Docket No. 50-373
Docket No. 50-374

We have received the attached Federal Emergency Management Agency (FEMA) letter dated July 1, 1985, and associated evaluation of the Alert and Notification System for LaSalle County Nuclear Generating Station in Seneca, Illinois.

The Federal Emergency Management Agency (FEMA) has completed an analysis of the prompt alert and notification system for the LaSalle Nuclear Power Station in Brookfield Township, Illinois. This review has been completed pursuant to FEMA rule 44 CFR 350; selected evaluative criteria and Appendix 3 in NUREG-0654/FEMA-REP-1, Rev. 1; and FEMA-43, the "Standard Guide for the Evaluation of Alert and Notification Systems for Nuclear Power Plants." The enclosed report entitled "LaSalle Nuclear Power Station Site-Specific Offsite Radiological Emergency Preparedness Alert and Notification System Quality Assurance Verification," summarizes the engineering design review, incorporates the results of the telephone survey of the public which was conducted immediately following the alert and notification system activation on December 4, 1984, and includes the results of the review of the other applicable evaluative criteria from NUREG

TIVATION DECISION/ACTION SEQUENCE DIAGRAM

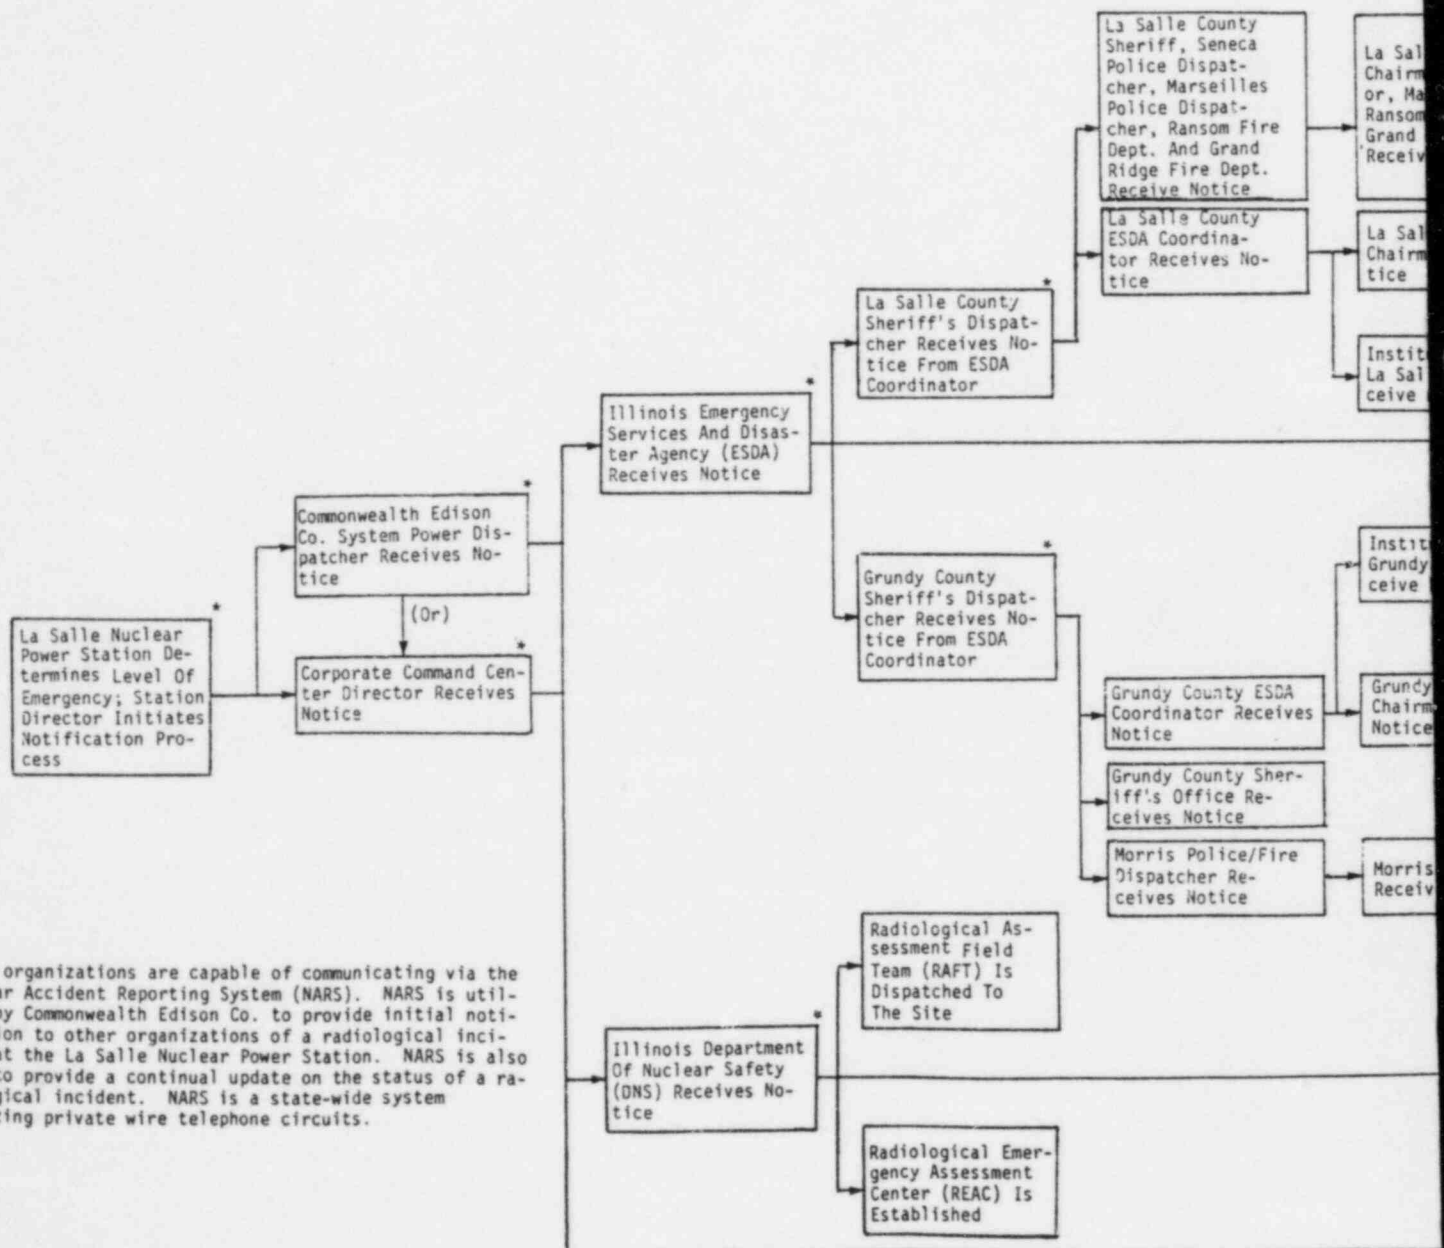
As Figure 1 indicates, these procedures satisfy FEMA-43 acceptance criteria. These current emergency procedures document the responsibilities concerning the alert and notification system activation process from the time a decision is conveyed via the Illinois Emergency Services and Disaster Agency Coordinator to the La Salle County and Grundy County Sheriffs' Dispatchers (who physically activate the sirens).

Activation of the route alerting system, as indicated in Figure 1, is the responsibility of local organizations. The mobile alert and notification network is designed around the keyhole concept such that the mobile alert and notification routes are centered on and prioritized by the appropriate three downwind sectors of the EPZ. In an accident situation, under the keyhole concept, the downwind sectors have

FIGURE 2
LASALLE SIREN CONTOUR PLOT

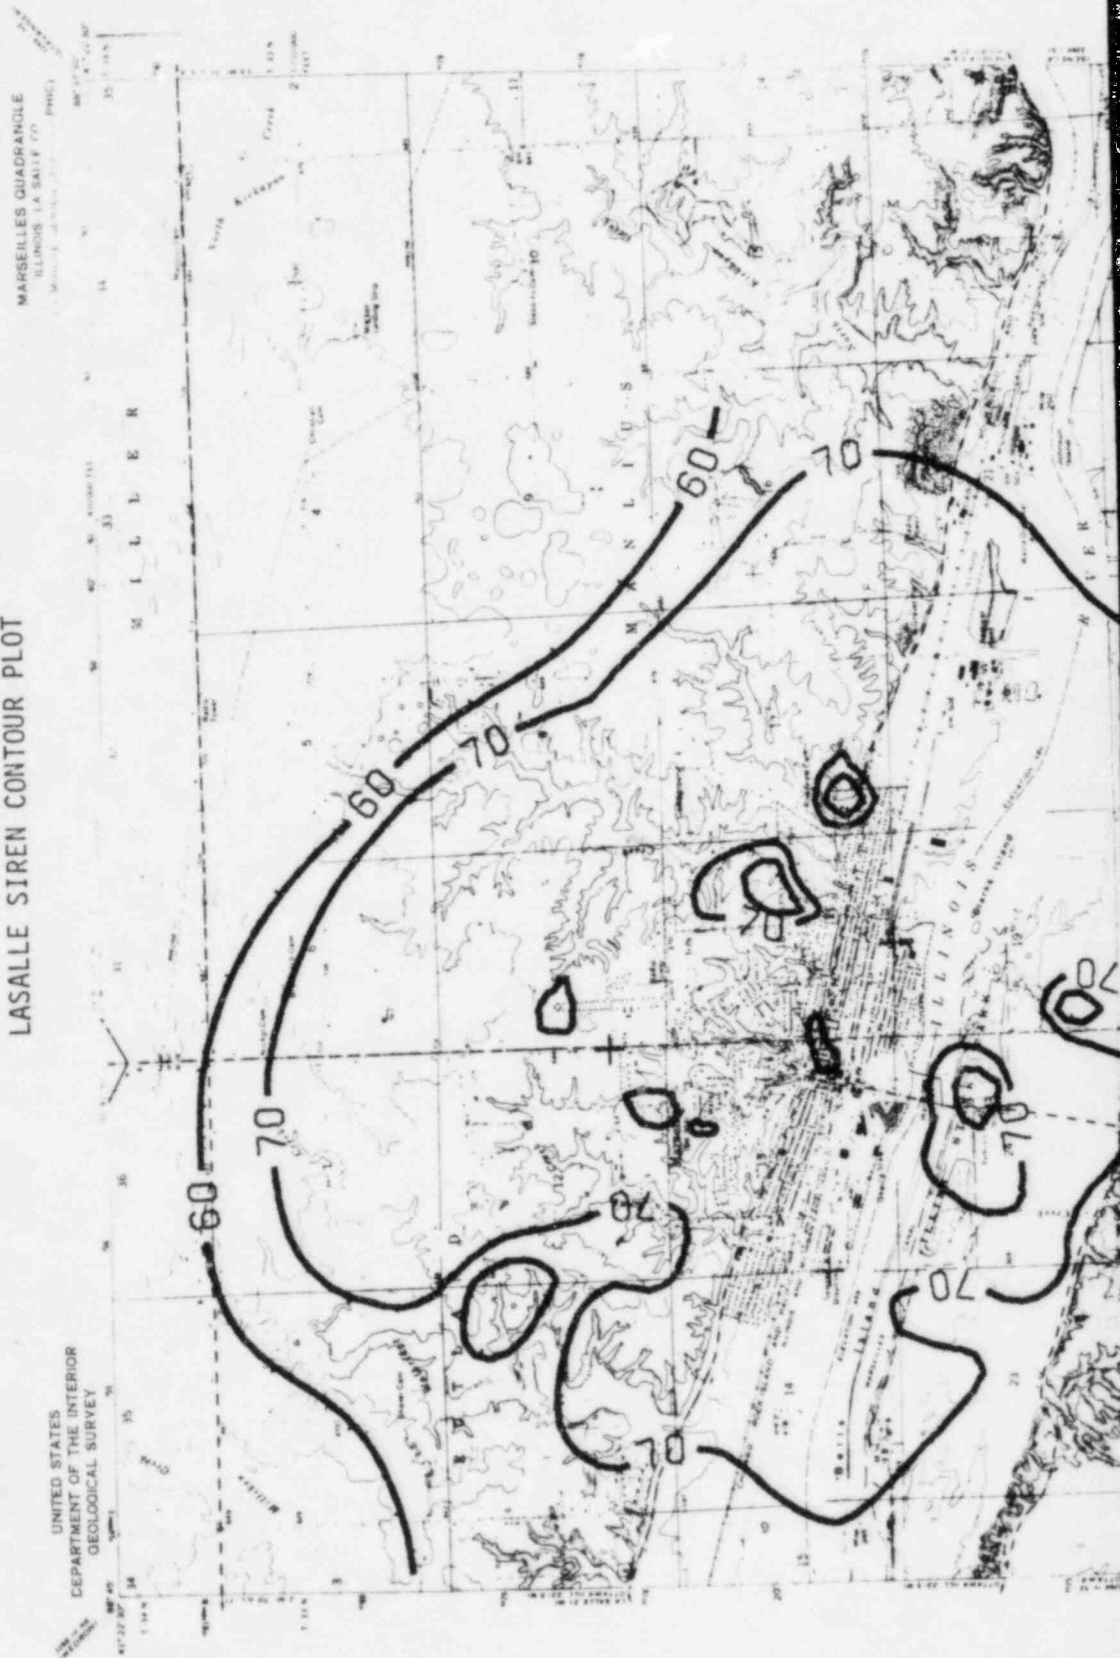
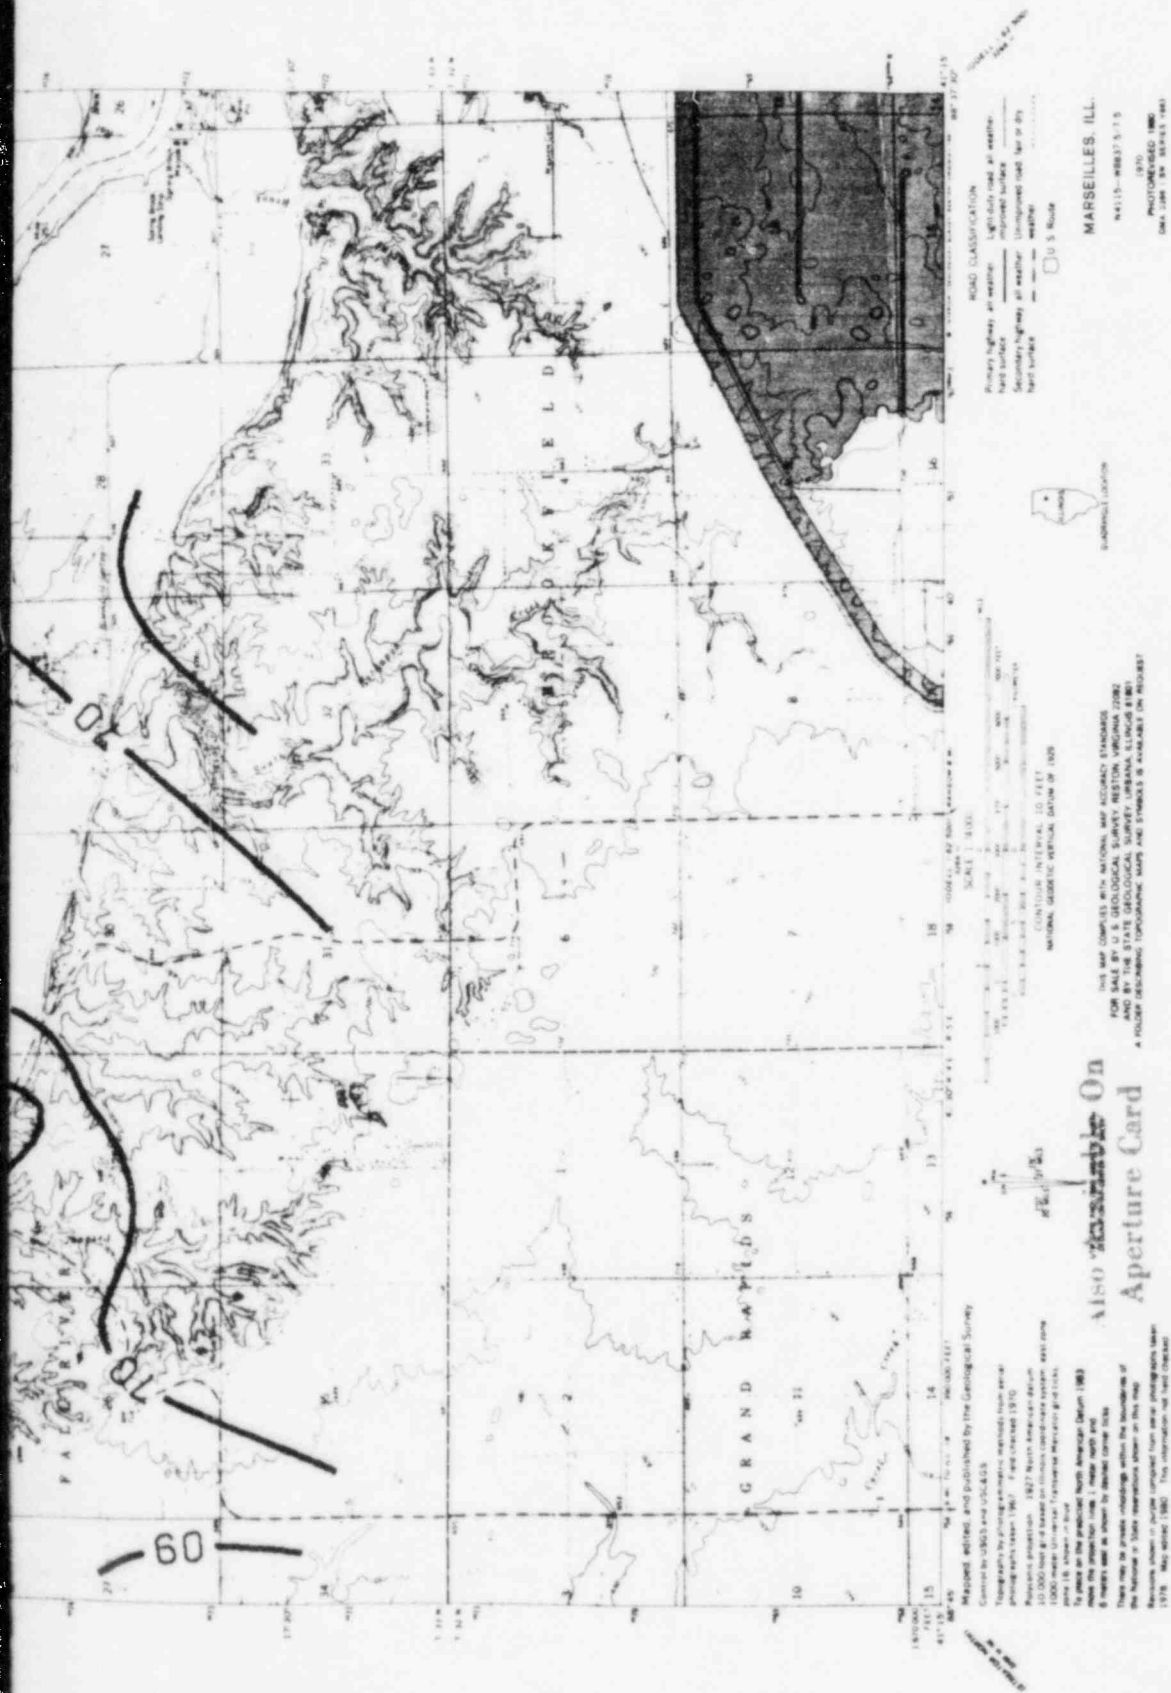
The results of the individual OSPM runs were combined to generate a comprehensive overview of the siren sound pressure levels over the Marseilles area. A logarithmic distance-weighted interpolation was performed on the output results of the three sirens to generate a grid of 44 by 44 dBC values over the entire map area. Each siren's dBC output was interpolated over this grid.

The maximum dBC values at each grid point were then used to compute the siren sound pressure level contours as shown in Figure 2. These contours account for the site-specific topographical and meteorological effects. Comparison of the OSPM predicted 70 dBC contours with the Design Report's 70 dBC contours indicates that the siren coverage (as discussed in the Design Report) in Marseilles is slightly more conservative than those coverages projected by OSPM.
